HISTORIC AND DESIGN REVIEW COMMISSION

HDRC CASE NO: 2019-427
ADDRESS: 519 S PRESA ST
LEGAL DESCRIPTION: NCB 902 BLK LOT 24 AT 724 ST MARY'S
ZONING: IDZ,HL
CITY COUNCIL DIST.: 1
DISTRICT: Lavaca Historic District
APPLICANT: Rebekah Perez/Work5hop
OWNER: WONG WAY LLC
TYPE OF WORK: Reconstruction of 1-story front porch with extension
APPLICATION RECEIVED: July 17, 2019
60-DAY REVIEW: September 15, 2019
CASE MANAGER: Stephanie Phillips
REQUEST:

519 South Presa St. Repair

Roof Plan

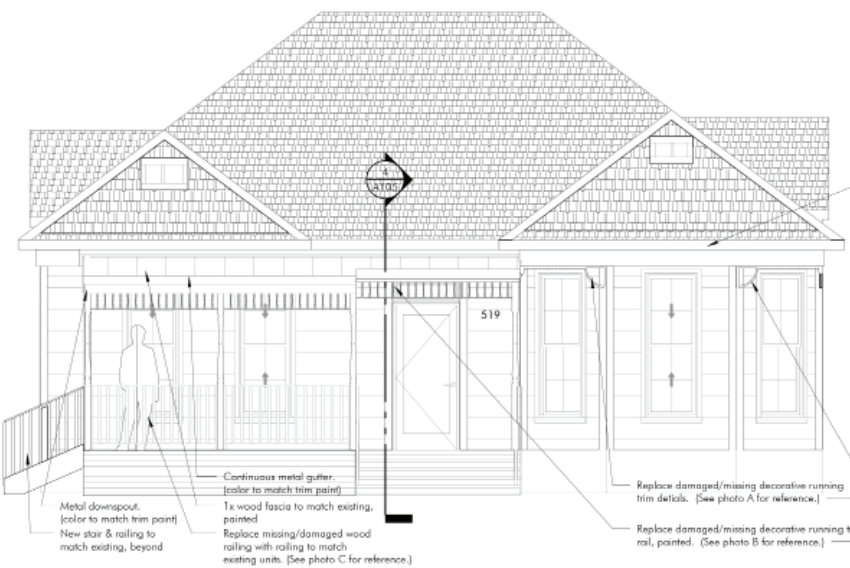
- c. PORCH EXTENSION – The applicant has proposed to extend the depth of the front porch by 3’-8” towards the street. The current depth is 6’-5”. This extension will require that the original configuration of the roofline be modified, including the decorative trim rail detailing, which will now be offset to adjust for the difference in roof pitch. As noted in finding b, the Guidelines state that porches should be reconstructed to match the original in design as closely as possible when documentation is available. The proposed extension will visually modify the porch from the public right-of-way, particularly its character-defining trim rail detailing. Staff does not find the proposal as designed consistent with the Guidelines.

- i. That the front porch extension be eliminated or redesigned to maintain the plane and design of the character defining trim rail detailing as noted in findings b and c. The applicant is required to submit updated drawings to staff for review and approval prior to receiving a Certificate of Appropriateness.
- ii. That the applicant complies with all setback requirements as required by Zoning and obtains a variance from the Board of Adjustment, if applicable.

519 South Presa St. Repair
Elevations

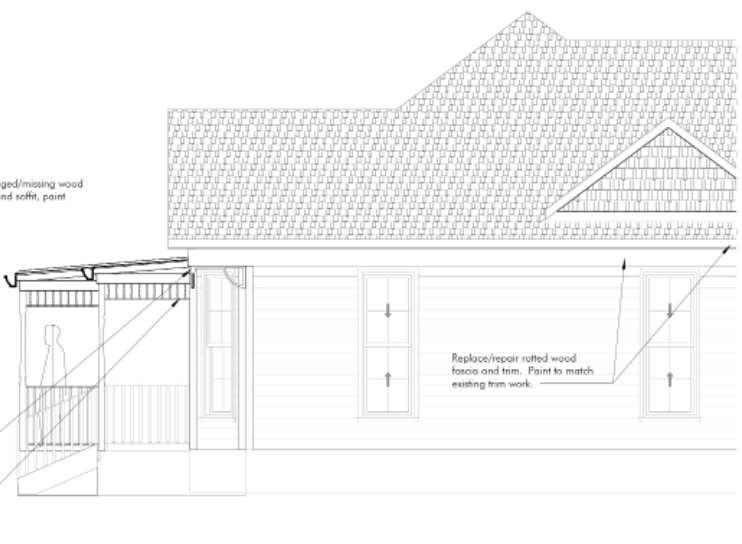
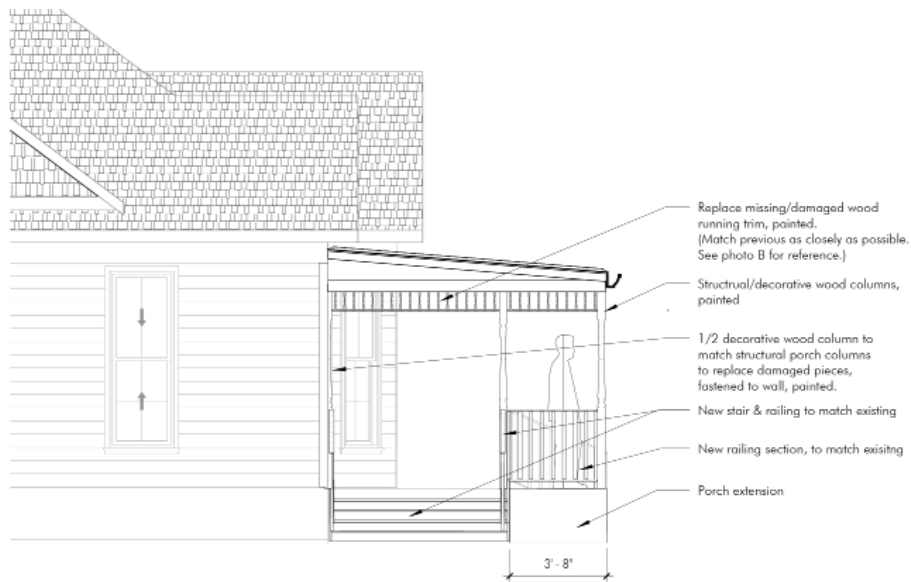
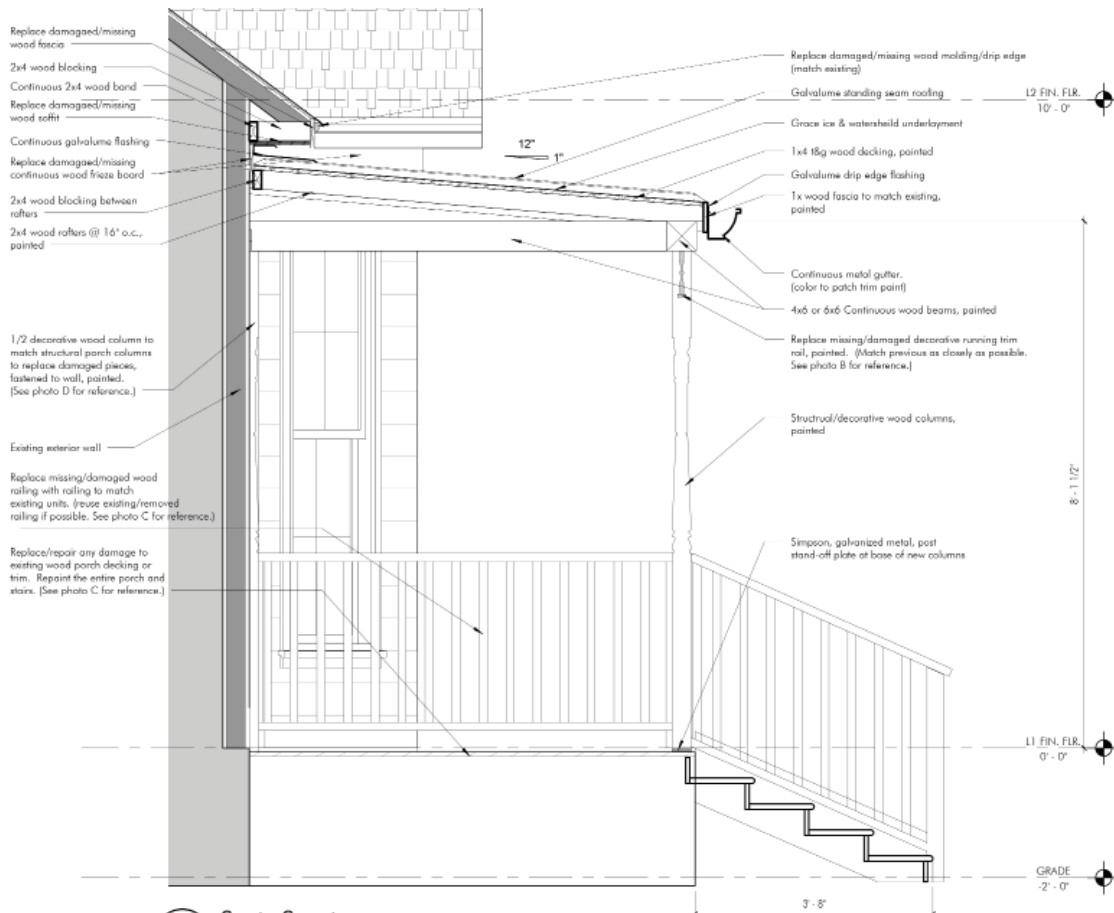
- d. STAIRCASE – The applicant has proposed to add a second porch staircase to the south (side) elevation of the primary structure. A roofline extension will not be required on this portion. According to the Guidelines, new porch elements, such as stairs, should be simple in design and should not detract from the character defining features. Staff finds this request appropriate.
